SUBJECT: AMENDMENT NO. 207 TO FACILITY OPERATING LICENSE NO. NPF-3 -  
DAVIS-BESSE NUCLEAR POWER STATION, UNIT NO. 1 (TAC NO. M93816)

DAVIS-BESSE NUCLEAR POWER STATION, UNIT NO. 1

AMENDMENT TO FACILITY OPERATING LICENSE

SAFETY EVALUATION BY THE OFFICE OF NUCLEAR REACTOR REGULATION  
RELATED TO AMENDMENT NO. 207 TO FACILITY OPERATING LICENSE NO. NPF-3

Figure 3.1-1 Boric Acid Addition System  
Minimum Required Volume as  
a Function of Boric Acid  
Concentration Required in  
Modes 1-4

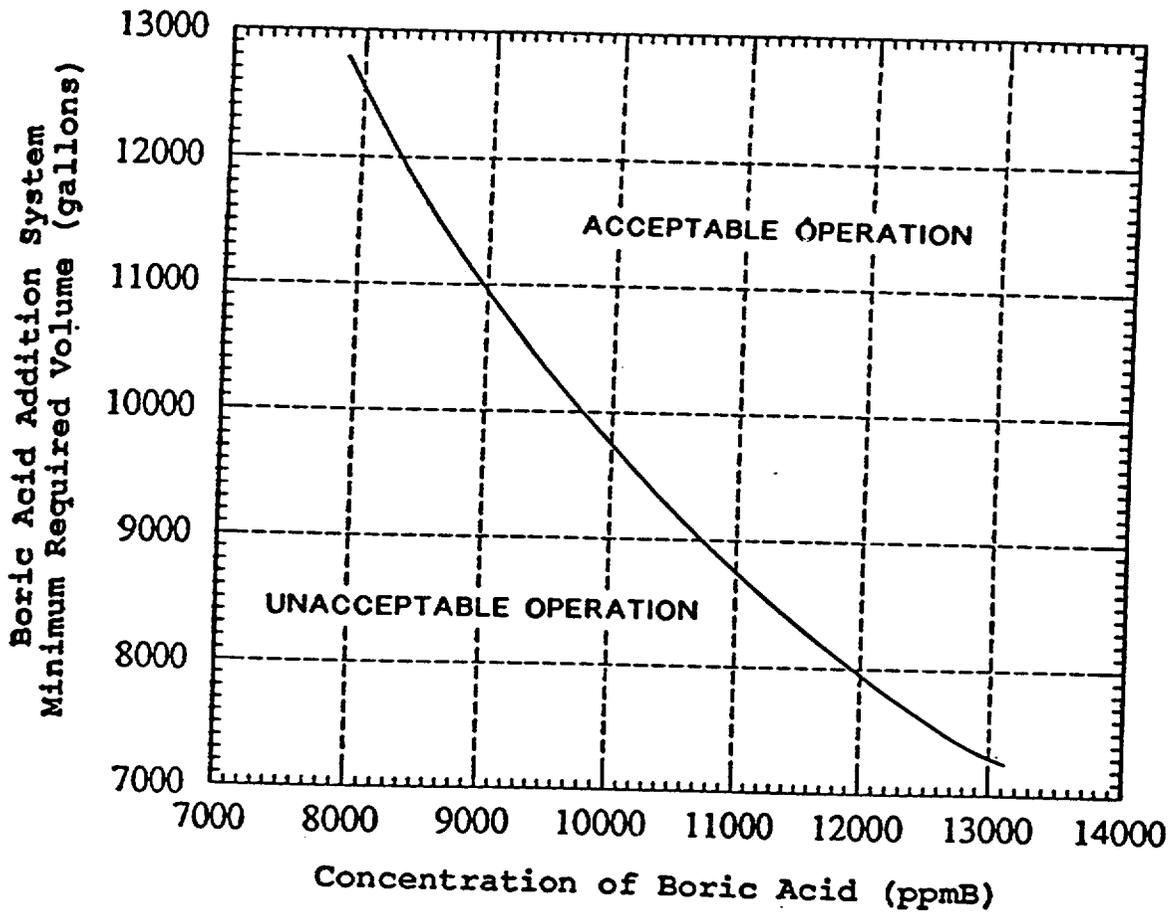
It is proposed to revise Figure 3.1.1, "Boric Acid Addition System Minimum Required volume as a Function of Boric Acid Concentration Required in Modes 1-4," in order to increase the minimum required volume.

For the maximum boration requirements from HFP to 200°F, it is proposed to increase the minimum volume requirement for the BAAS from 9,071 gallons at a minimum boric acid concentration of 7875 ppm to 12,200 gallons, and to increase the minimum volume requirement for the BWST from 75,300 gallons at a minimum boron concentration of 2100 ppm to 86,700 gallons at a minimum boron concentration of 2600 ppm. It is also proposed to add a statement explaining why the volume requirement of 12,200 gallons is a lower value than that shown in TS Figure 3.1-1.

The reload report for Cycle 11 will include the necessary reanalyses for inadvertent boron dilution as well as for any adjustment to lithium control to maintain the RCS pH. The proposed changes ensure an adequate concentration of boron is available in the BAAS to maintain a 1%k/k shutdown margin. Based on the above considerations, the staff finds these changes appropriate and acceptable.
